TOWN OF CORTLANDT PLANNING BOARD

Planning Board Work Session & Meeting Tuesday July 7, 2026

b. **PB 2025-7 Yeshiva New Dormitory & Campus Upgrades**

Application of the Yeshiva Ohr Hameir for Site Plan approval, an amended Special Permit for a University, College or Seminary and for Wetland and Tree Removal Permits for a proposed 51,730 sq. ft. dormitory building, a 1,640 sq. ft. storage building, the repurposing of other buildings on site, and site improvements including stormwater, landscaping and building façade renovations located at the existing Yeshiva Ohr Hameir campus at 141 Furnace Woods Rd. Drawings revised June 12, 2026. (see prior PB 7-09)

WOOD CHIP TRAIL DETAIL
N.T.S.

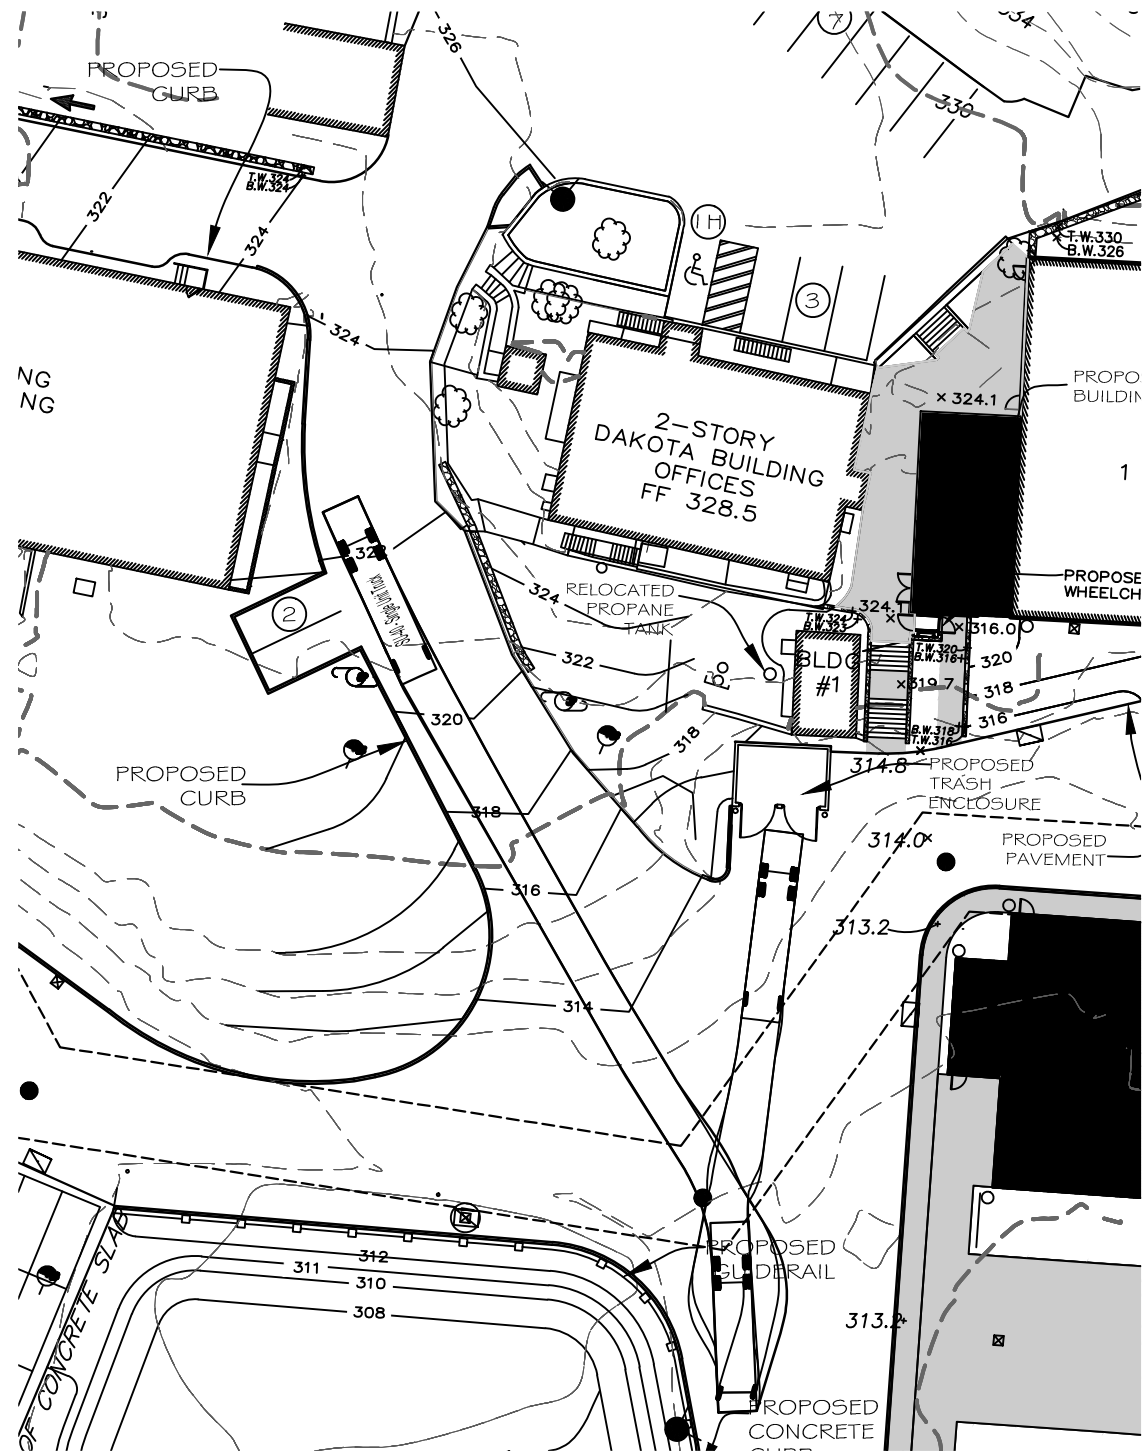
Sheet 17 – Walking Trail

Response 1: A detail of the wood chip walking trail is provided on sheet 16.

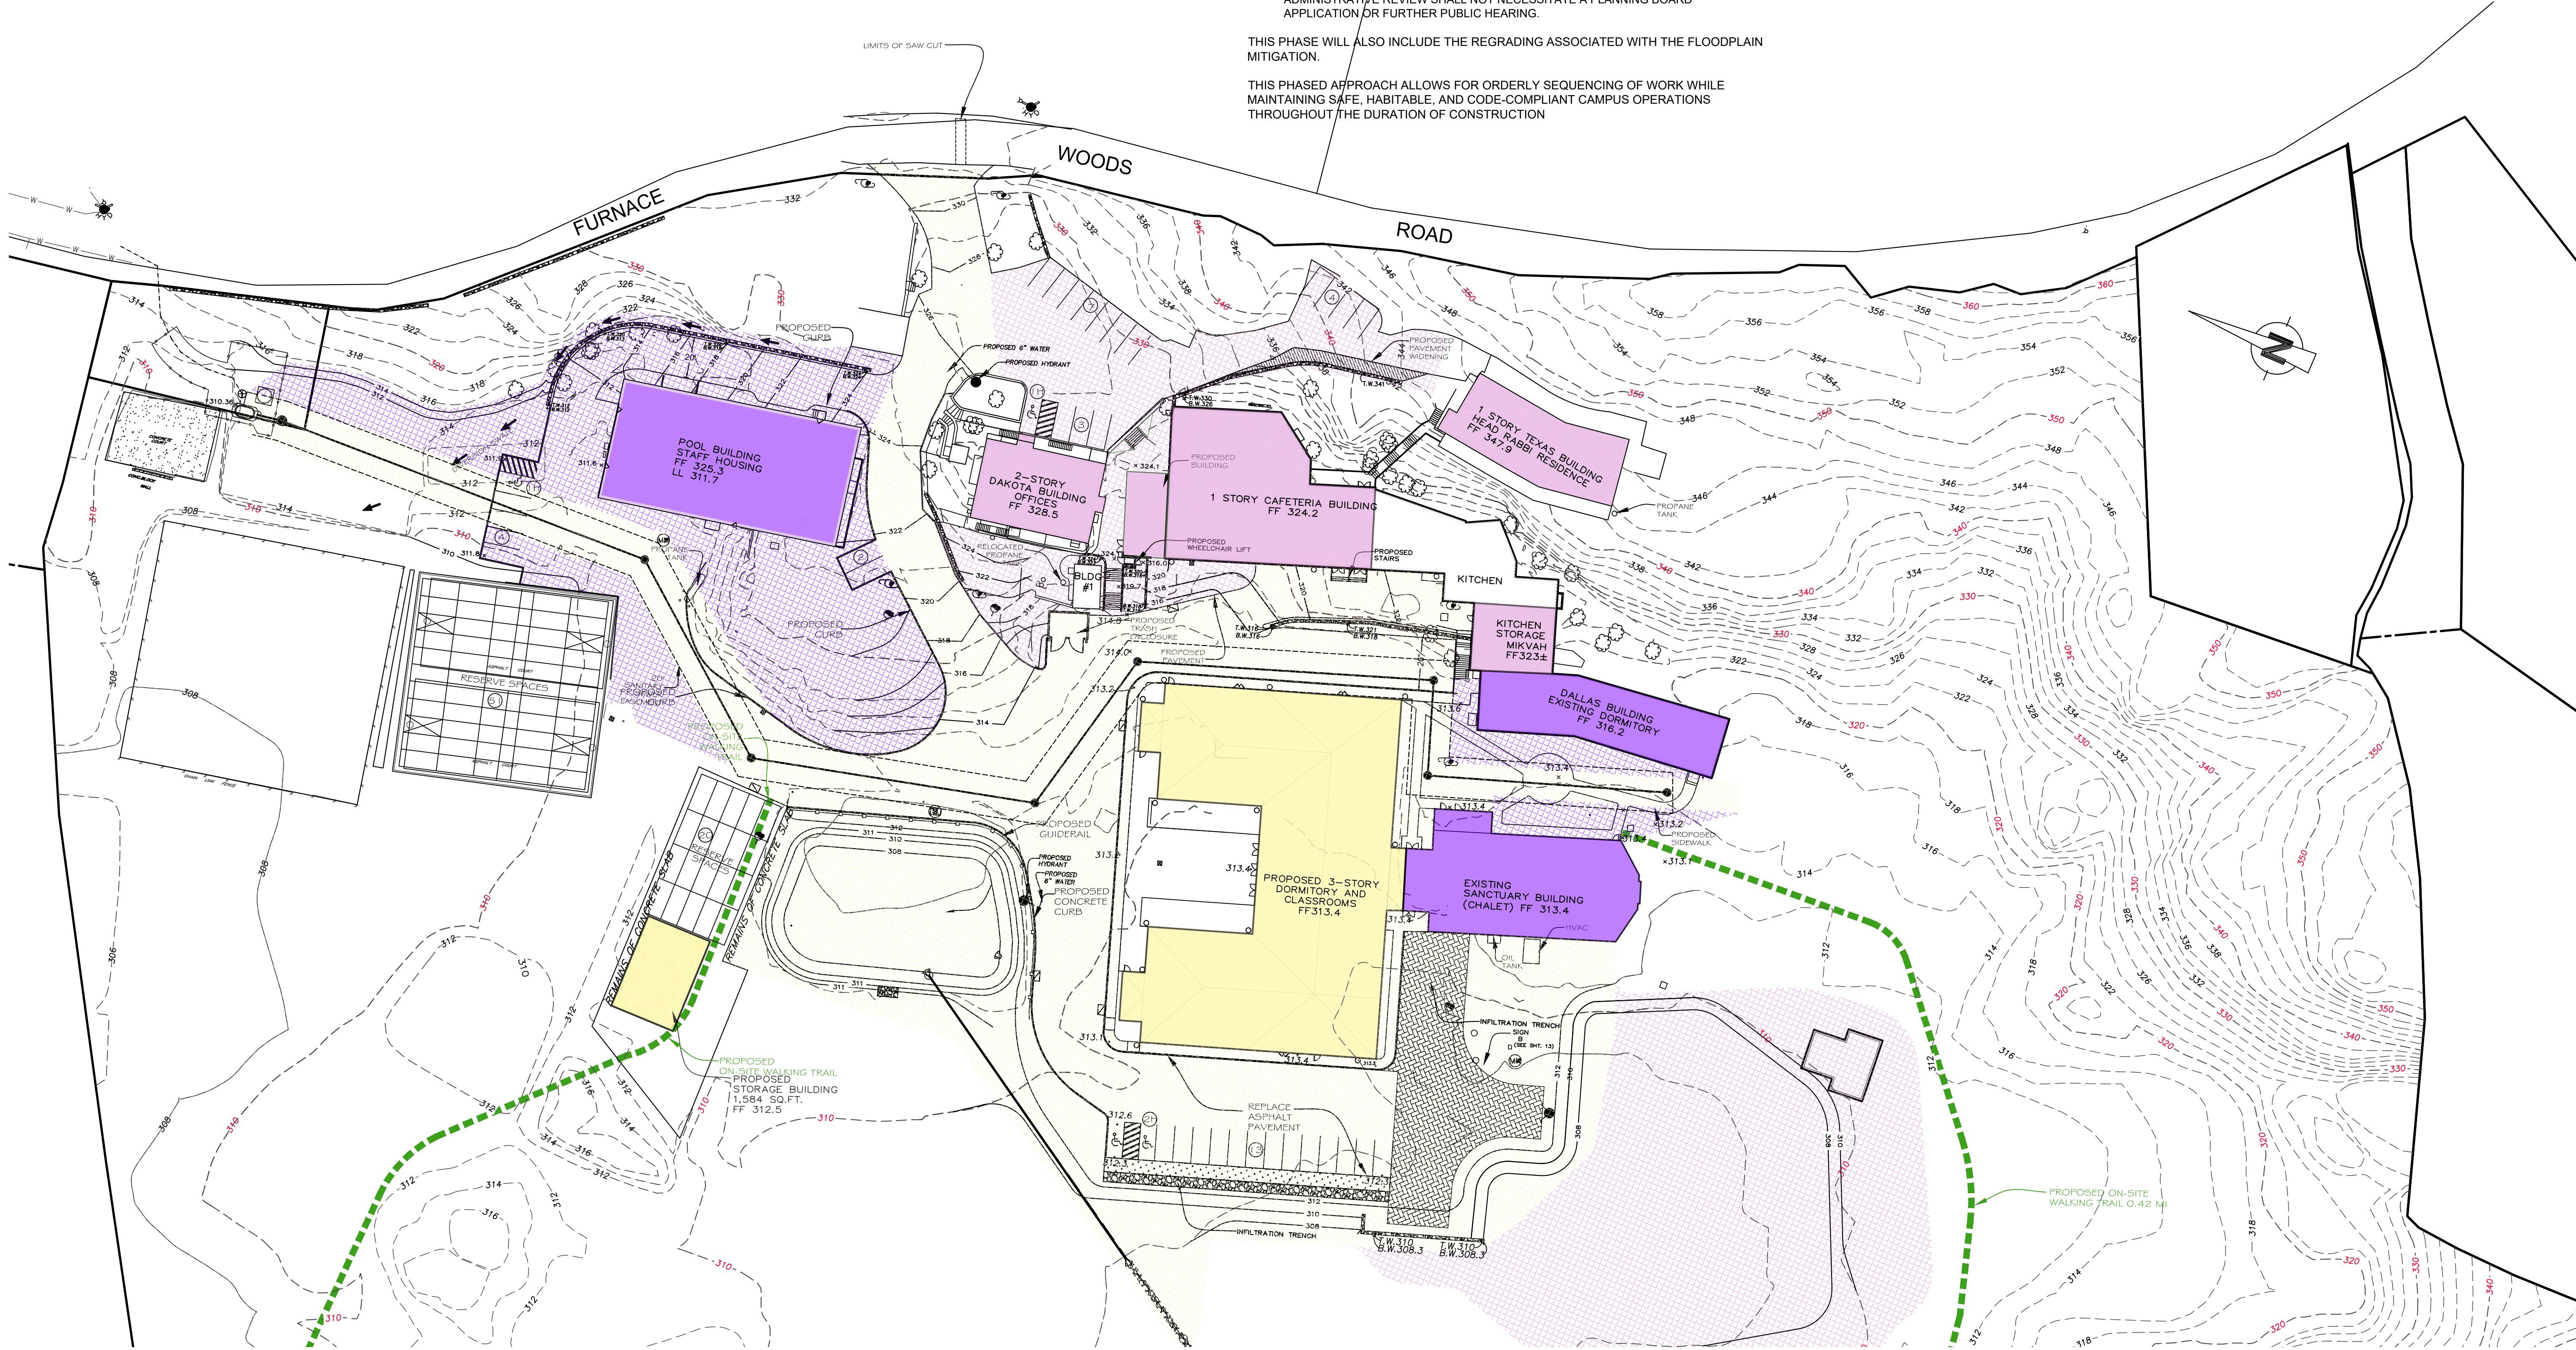
Sheet 16- Phasing Plan

Response 1: The revised phasing plan (Sheet 17) addresses the student population during the 3 phases of construction.
